Connecticut River Conservancy

February 26, 2025

Re: Bellows Falls Hydroelectric Project (FERC No. 1855) draft 401 Water Quality Certification
(ENB ID: PN24.0018903)

Figure 2 Illustration of the ability of the use of LiDAR to accurately assess vegetation cover and slope/volume changes of riverbanks.

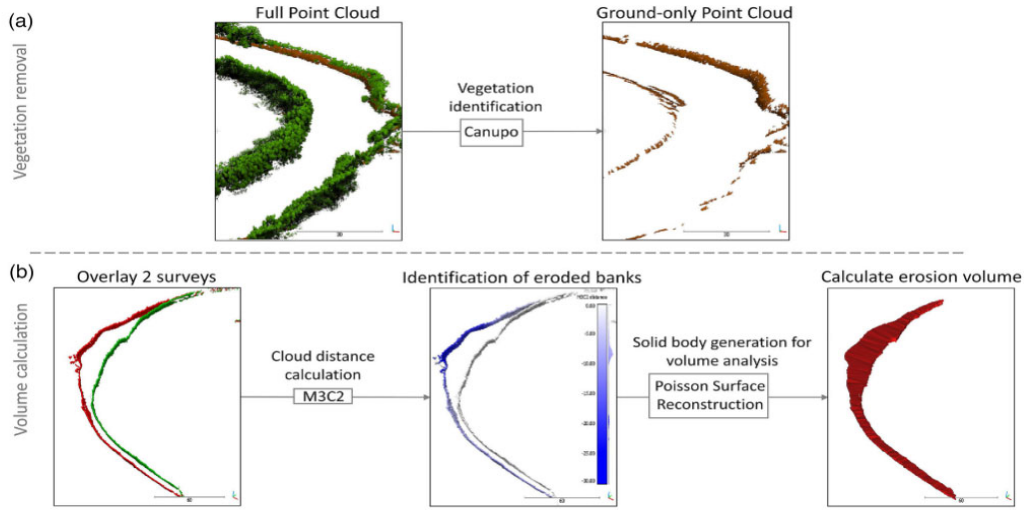
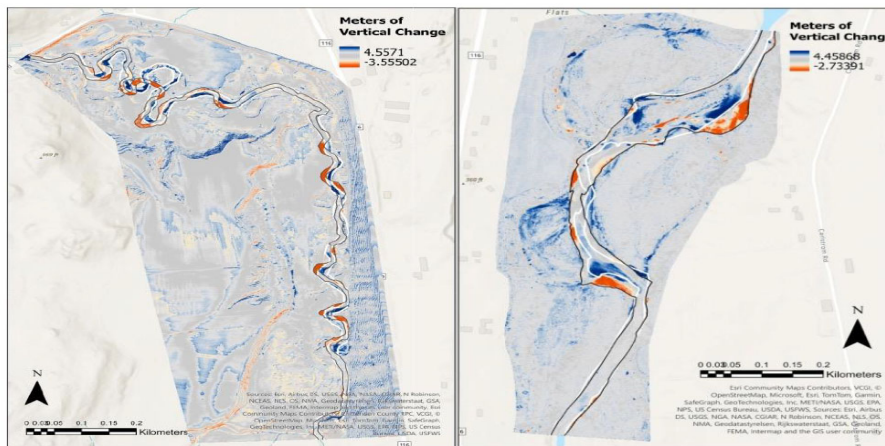
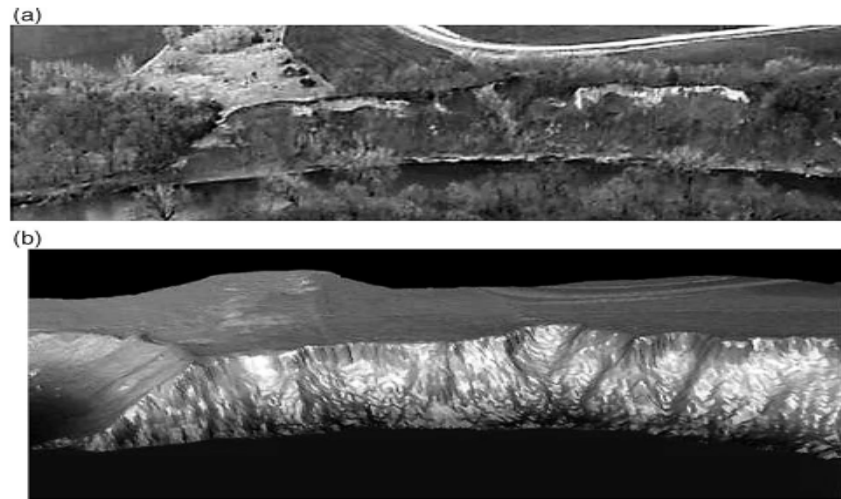
- Due to the advancement and cost efficiency of LiDAR technologies for use in the monitoring of rivers and bank stability, obtaining riverbank topographic data and vegetative cover, even over an impoundment as long as one behind the Bellows Falls Dam, is strongly recommended. Such data to be collected will be an initial baseline flyover via drone or helicopter survey to collect the above and below water surface slope conditions pre-change to IEO. Such data can be used to identify existing slope movements and vegetative covers. In subsequent years, say biannually, or after significant events such as flooding caused by tropical storms, nor'easters, or summer catastrophic storms such as have occurred over Vermont in the last two years a flyover LiDAR (upland and bathymetry) survey must be conducted. Subsequent years can be precisely overlain over prior years to calculated changes in slope elevations. Especially following significant flooding, the impacts between regional storm events versus bank instability caused by operations can be distinguished. In consulting with remote sensing/survey firms who conduct such services, each survey, including analysis and reporting can be completed for less than \$50,000 in 2025 dollars, proving VT DEC and the public with a more comprehensive, quantitative assessment of the stability of the riverbanks and the vegetative cover that adds to river stability. Such a cost would be comparable, if not less costly than ground surveying the limited number of river sections previously completed to determine the overall stability of slopes within the subject impoundment. The surveys conducted would then be overlain with the HEC-RAS 2-dimensional models to evaluate natural and operational flows and how they may be contributing to riverbank instability. The following figures illustrate the usefulness of this technology and how it has been researched and developed for a situation such as for the Bellows Falls Dam impoundment reach.

Figure 1: West River confluence with the Connecticut River. ANR Natural Resources Atlas

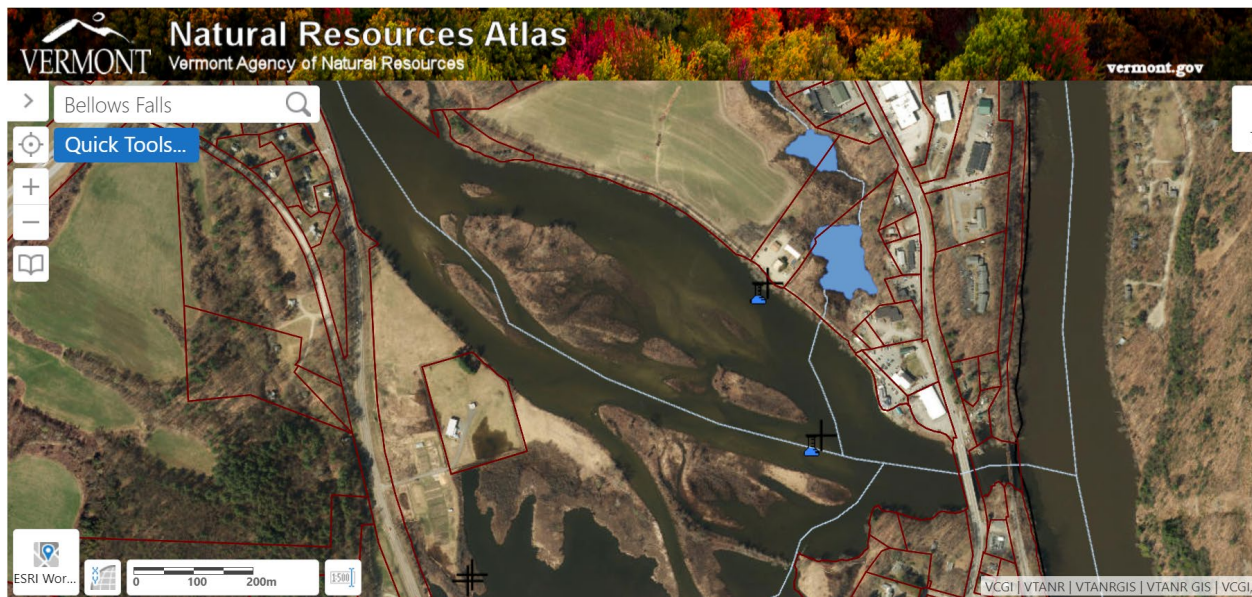
Because of many decades of peaking operations, the Wilder, Bellows Falls, and Vernon impoundments have been functioning essentially as lakes, with long stretches of low flows during much of the day. Consequently, tributaries that empty into each of those impoundments have a sediment wedge at the confluence of the Connecticut River. This is clearly visible on the Vermont Agency of Natural Resources (“ANR”) Atlas, such as the example in Figure 1 from the West River.

CRC staff have personal experience attempting to recreate at this location in Brattleboro and can attest to sediment buildup at the mouth of the West River that reaches up to 1.3 miles upstream. The sediment load is so high, that when GRH is moving water through the Vernon facility and reducing the surface water level of the Vernon impoundment, it can be too shallow to boat in this area. Additionally, below is an image, taken on May 1, 2019, during a drawdown of

Figure 1: Water Surface Elevation as measured in the lower, middle, and upper Wilder impoundment in 2014, demonstrating peaking frequency as well as the higher water level and greater magnitude of fluctuation in relation to distance upstream from the dam.

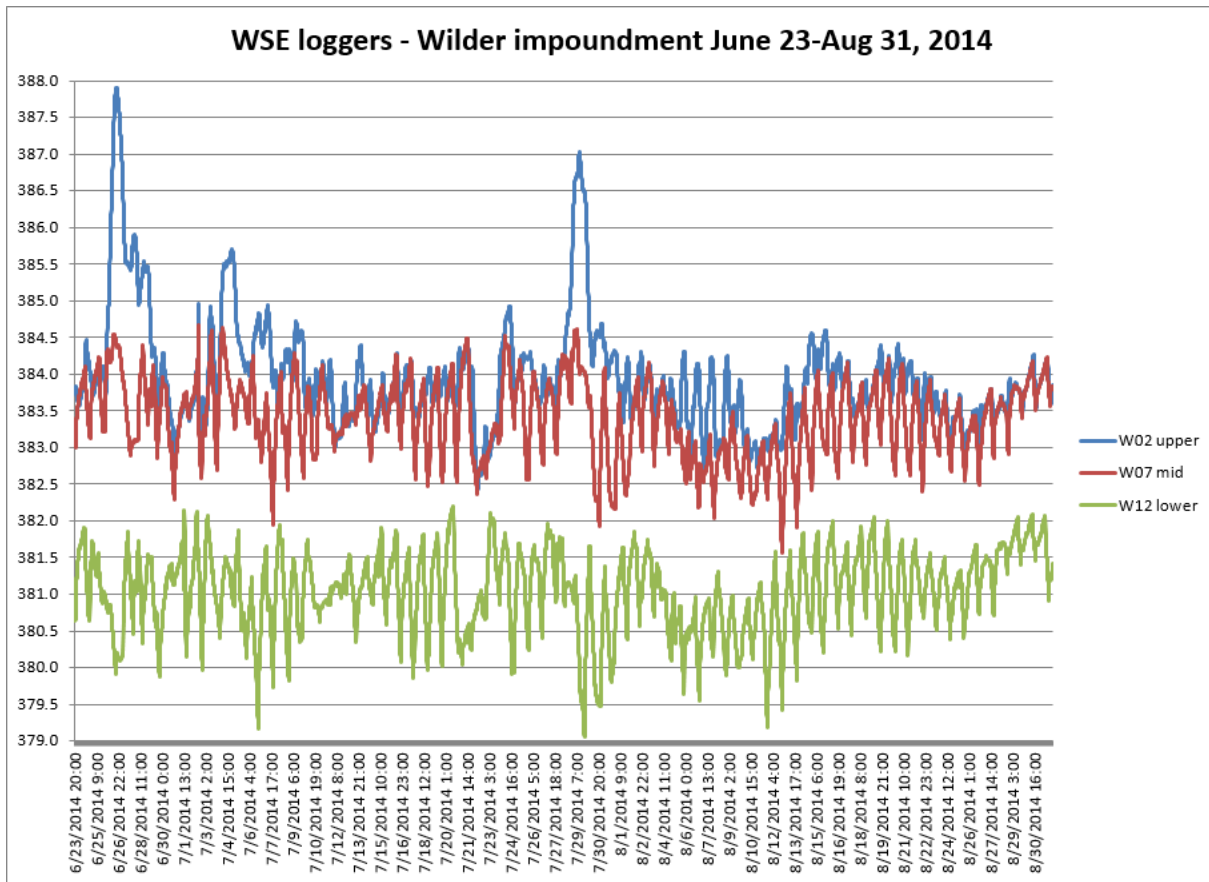
In addition, Figure 1 below provides an example illustrating the difference between surface water elevation changes in the Wilder impoundment during current operations at different distances upstream of the dam. There is greater magnitude of surface water elevation changes in the upper ends of the impoundments due to a delayed wave flow effect as well as peaking flows being passed down from 15 Mile Falls.

Given the specific influence of peaking flows from the Fifteen Miles Falls projects that impact the upper end of Wilder impoundment, and the lack of analysis in regard to the preferred operation under the new license, GRH must be required to support an ongoing multi-decade monitoring program to assess any ongoing potential impacts of changes in operation on the banks of the Wilder impoundment and in changes in sediment deposition throughout the project area, and subsequently take responsibility for mitigation required to address those impacts.

Figure 5.4.2-6. Position on bank of normal operating range aligns with location of notching at 02-W03 (Bellevance Site).

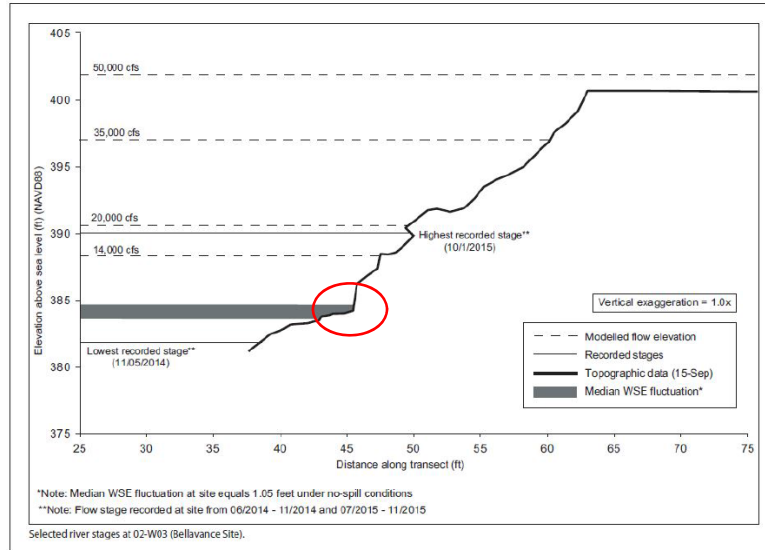
- “Banks composed of non-cohesive sediments and interlayered cohesive and non-cohesive sediments are the most susceptible to erosion.” (page 10, Study 2 and Study 3 Report)
- “Normal project operations result in daily or sub-daily fluctuating water levels. At many sites, the position of those daily fluctuations on the bank aligns with the location of notching at the base of the bank”(page 53, Study 2 and Study 3 Report). Figure 5.4.2-6, below, from the Study 2 and Study 3 Report illustrates this observation, with the location where the WSE fluctuation based on normal operating range intersects with the notch in the river bank, circled in red.

- “Fluctuations in WSE related to normal project operations under no-spill conditions are consistent with notching and overhangs observed at the base of 8 of the 21 monitored banks at some point during the two-year monitoring period (Appendix A). Erosion can result from seepage forces generated by WSE fluctuations (Budhu and Gobin, 1995) with overhangs developing when seepage is focused along a single layer (Fox and Wilson, 2010).” (page 111, Study 2 and Study 3)
- “The character of sediments in the study area creates banks with limited resistance to erosion. The bank sediments at the monitoring sites, representative of the study area as a whole, are nearly ubiquitously comprised of fine-grained and unconsolidated floodplain or glaciogenic sediments particularly prone to erosion (see Appendix A stratigraphic columns). Frequently observed inter-beds of permeable sand and less
